UNION CARBIDE CORPORATION

CORPORATE RESEARCH LABORATORY

Ref: (a) UCC Ltr. 12/28/78<sup>7</sup> Application To Amend SNM-639.

Our letter of application (Ref. (a)) is hereby changed in accordance with discussions held between UCC & USNRC regarding assurance of criticality safety.

TOLERANCES ±	UNION CARBIDE CORPORATION CORPORATE RESEARCH LABORATORY TUXEDO, NEW YORK		
DRAWN W.R. 5 MAY '78	STORAGE RACK		
CHECKED:	SCALE: 1" = 1/4"	SIZE: A	DRAWING NO.: 101349
DATE:

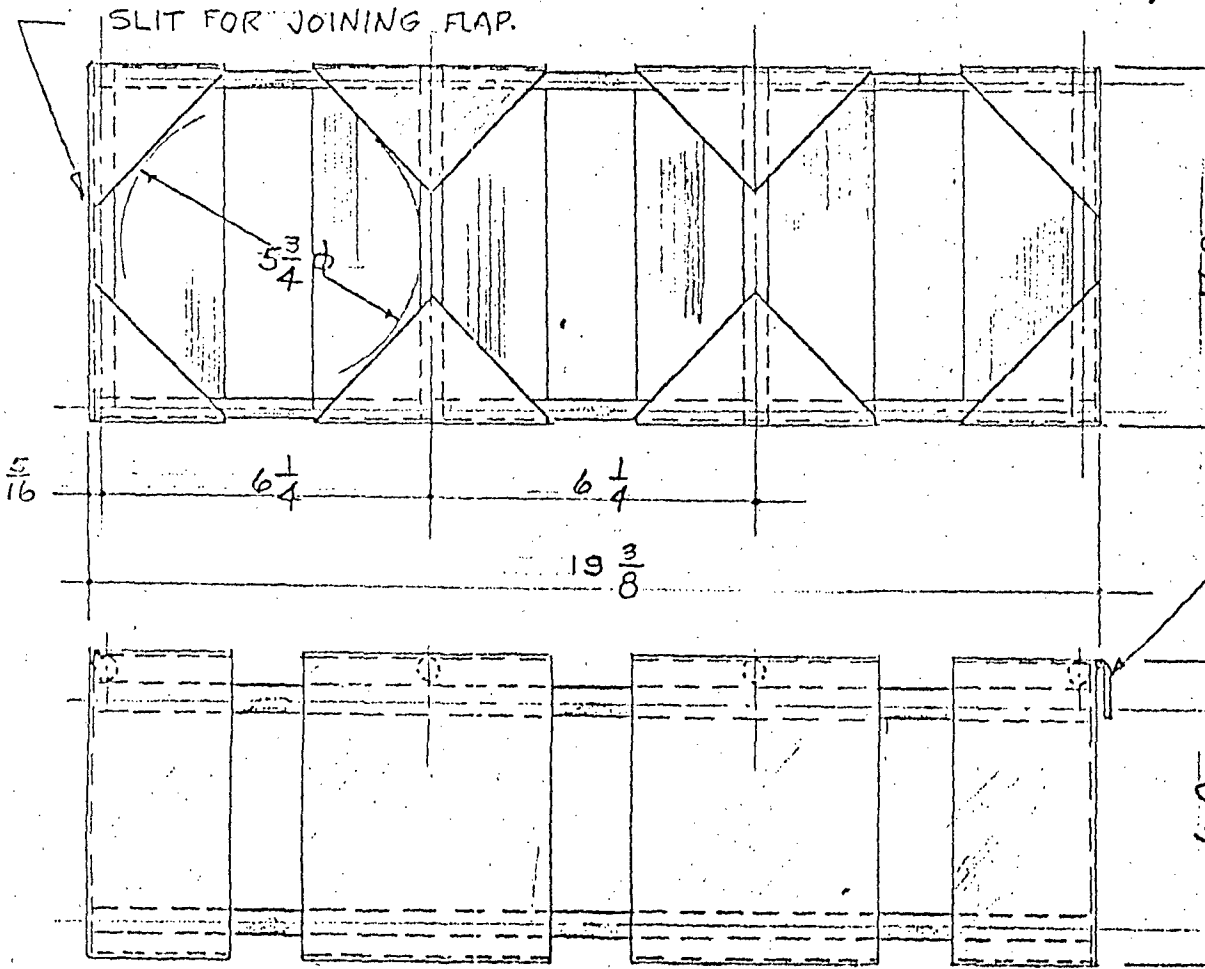
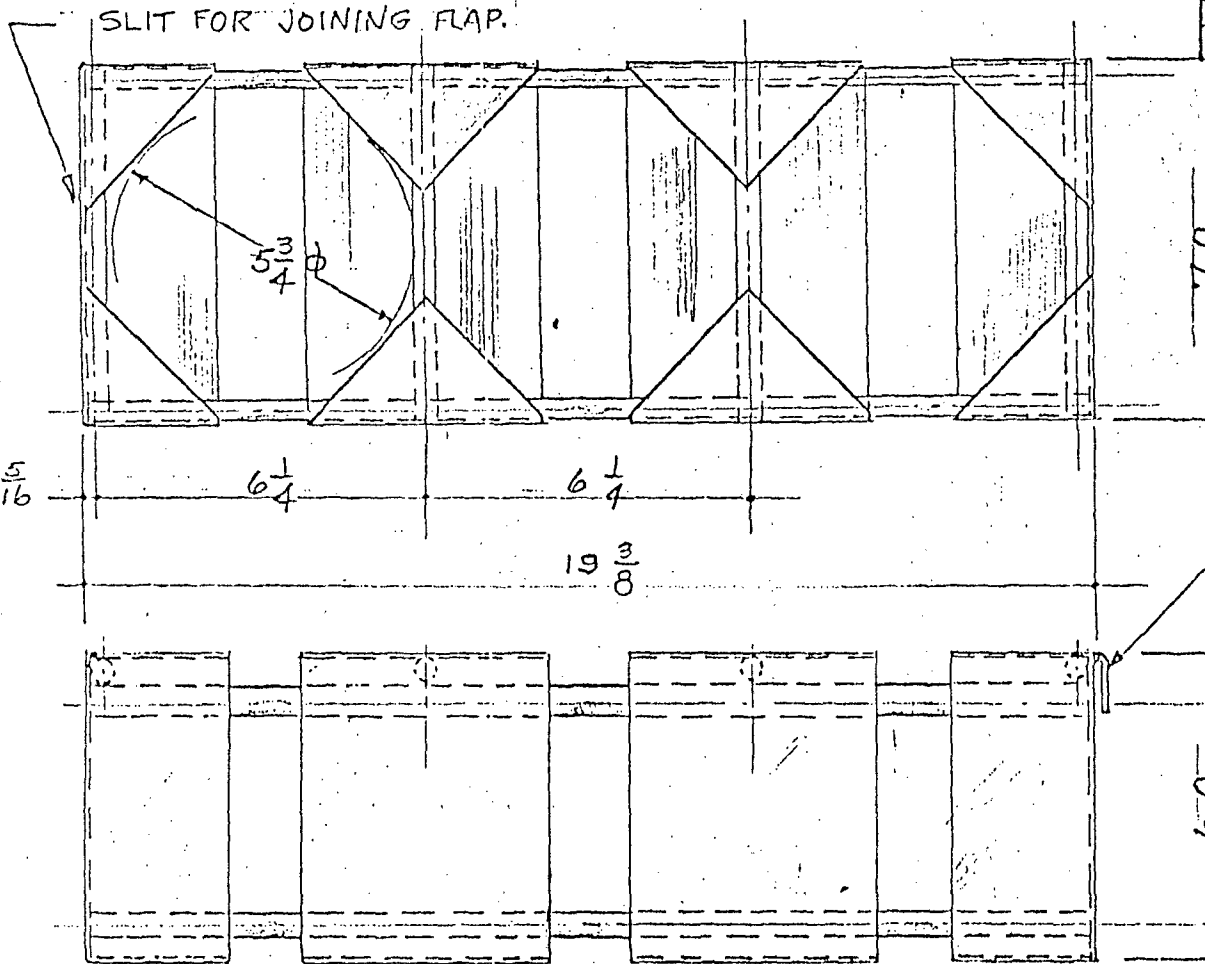
1. Each waste container is a right cylinder of aluminum metal, 5.25" OD x 0.125" wall (minimum) (I.D. < 5.0"). There is no restriction on height but each cylinder will typically be < 18" high.
2. Aluminum waste containers will be stored in a linear array within the waste storage hot cells which are not used for storage of boro-silicate glass bottles containing U-235. A diagram of a typical aluminum waste container storage is shown on the enclosed drawing.
3. Aluminum waste containers, one at a time, will be filled in an isotope processing cell and will be moved to a hot cell which is equipped with a rack for storage of the aluminum containers. For disposal, the aluminum waste containers will be placed in 55 gallon 17H steel drums (2 per drum, 300 gms U-235 max.). Arrangement of drums will be as shown in the enclosed drawing.
